Product Update

SC100 Speed Controller

New Firmware – Release 1.7.0

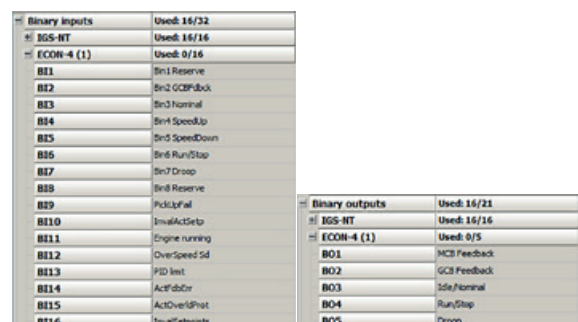
Protection against loss of RPM signal:

In case there is a sensor fail like a broken wire or broken sensor the engine speed is dropped down very fast (sometimes due to broken sensor it is not always exactly zero rpm). The actuator would normally react as low speed and due to active regulation, it would try to more and more open the actuator and it leads automatically to overspeed which is not desired.

To prevent this situation there is a function which can identify loss of RPM signal.

There is a new setpoint RPMdropFail which is defined as the maximal RPM drop in 100 ms. In case the rpm drop is higher than value of this setpoint during 100 ms, the speed governor evaluates the situation as speed sensor fail and immediately closes the actuator. The output BO9 from the speed governor LBO PickupFail is activated for 3 s (in case the speed drops immediately to zero it will be possible to catch the situation).

It is strongly recommended to configure user protection Level 2 on the PickupFail signal in the configuration tool (GenConfig), to prevent unwanted behaviour or next starts. When LBO PickupFail is deactivated (after the 3 s delay), the speed governor starts opening the actuator again.
